# Mobile Pentium® II Processor Specification Update

Release Date: December 1999

Order Number: 243887-016

The Mobile Pentium® II processor or the Intel® Pentium® II Processor Mobile Module may contain design defects or errors known as errata which may cause the product to deviate from published specifications. Current characterized errata are documented in this Specification Update.

OLD MOBILE PENTIUM® II PROCESSOR IN MINI-CARTRIDGE PACKAGE LABEL WITH SUPPLIER  
MATRIX MARK

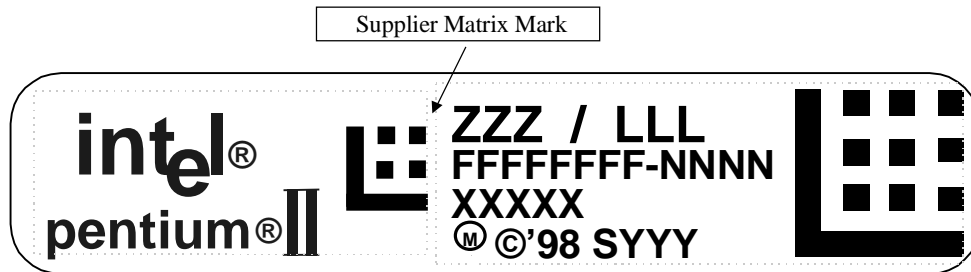
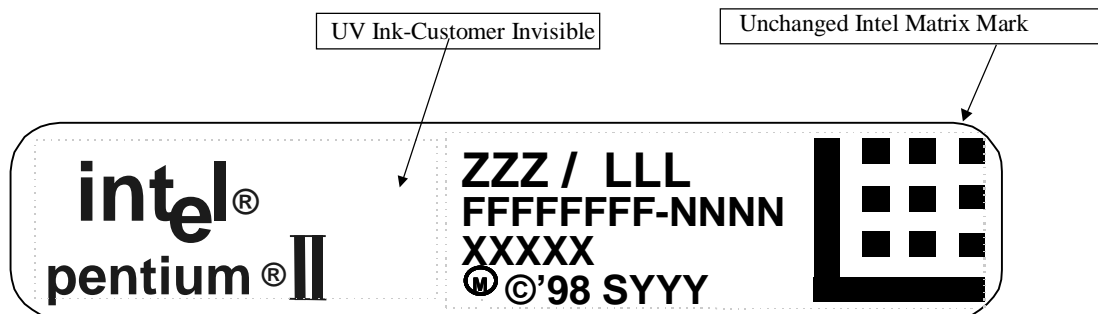
NEW MOBILE PENTIUM® II PROCESSOR IN MINI-CARTRIDGE PACKAGE LABEL WITH SUPPLIER MATRIX  
MARK REMOVED

**Figure 5.6. Cross Sectional View with Vertical Dimensions**

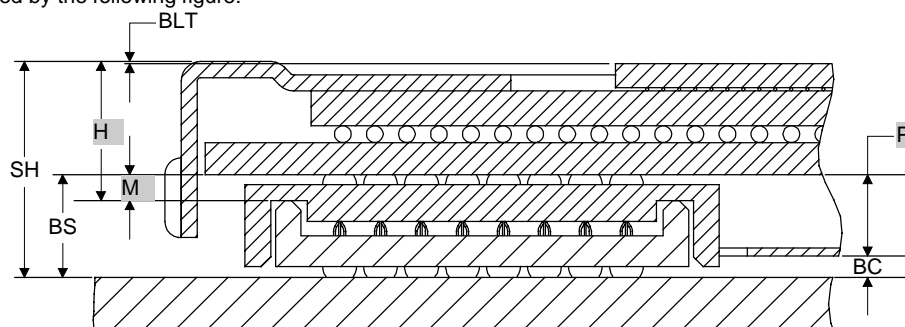
Figure 5.6 in the *Mobile Pentium® II Processor at 233 MHz, 266 MHz, and 300 MHz* datasheet should be replaced by the following figure:

**Figure 5.3. Surface-Mount BGA1 Package—Top and Side View**

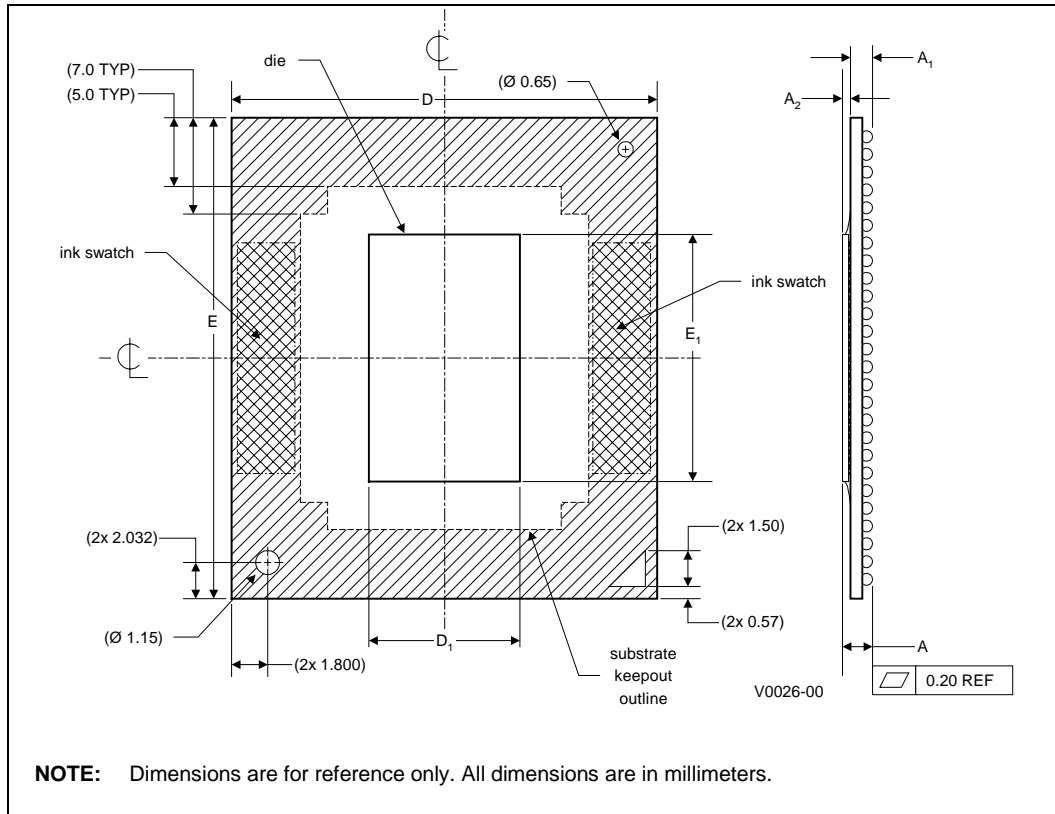
The following table and figures show the updated mechanical specifications for the BGA1 package, listed as Table 5.2, Figure 5.3 and Figure 5.4, respectively, in the *Mobile Pentium® II Processor in BGA Package at 366 MHz, 333 MHz, 300PE MHz, and 266PE MHz* datasheet.

**Figure 3.3 Generic Clock Waveform**

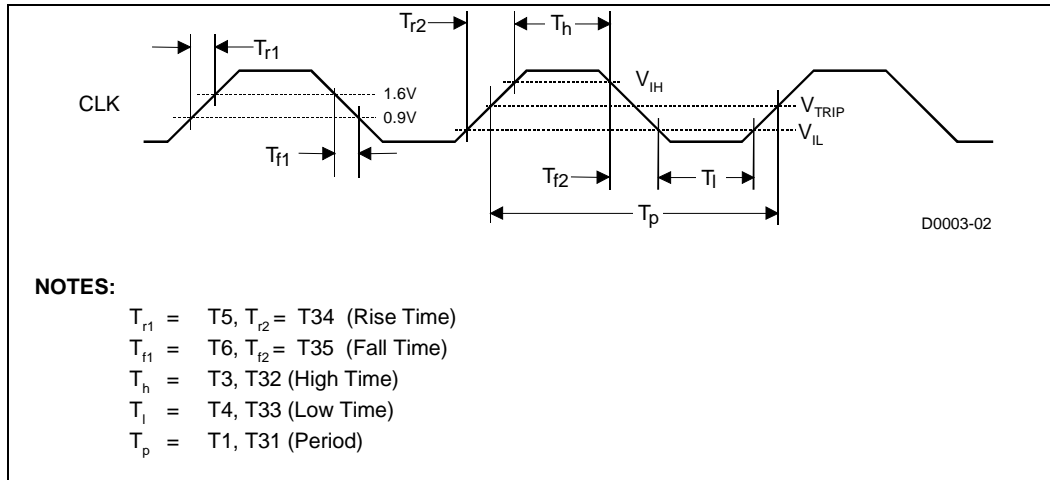
Figure 3.3 in *Mobile Pentium® II Processor in Mini-Cartridge Package at 366 MHz, 333 MHz, 300PE MHz, and 266PE MHz* datasheet (Order Number 245108), and the *Mobile Pentium® II Processor in BGA Package at 366 MHz, 333 MHz, 300PE MHz, and 266PE MHz* datasheet (Order Number 245106) has been updated. The following figure is to replace the ones in the above documents.

Figure 1. TAP Gageable Thread Clarification

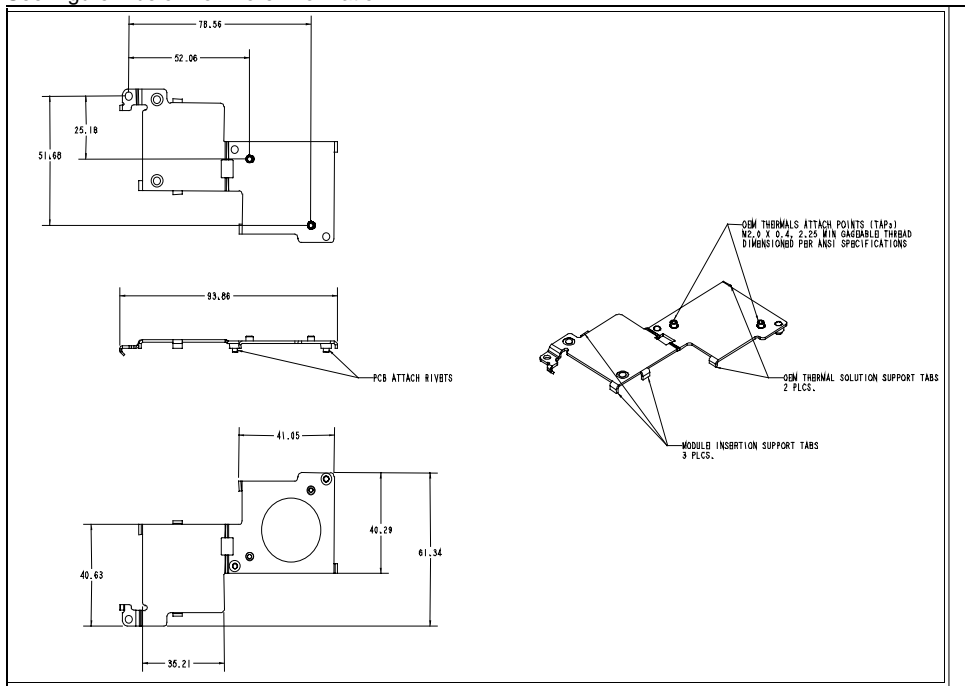
In the *Intel® Pentium® II Processor Mobile Module : Mobile Module Connector 1 (MMC-1)* and the *Intel® Pentium® II Processor Mobile Module : Mobile Module Connector 2 (MMC-2)* datasheets (Order Numbers 243667 and 243668, respectively), the thermal attach point (TAP) gageable thread specification was not clearly identified in Figure 14, of Section 5.2. The following is the TAP clarification:

OEM Thermal Attach Points (TAPs) M2.0 x 0.4, 2.25 min gageable thread dimensioned per ANSI specification.
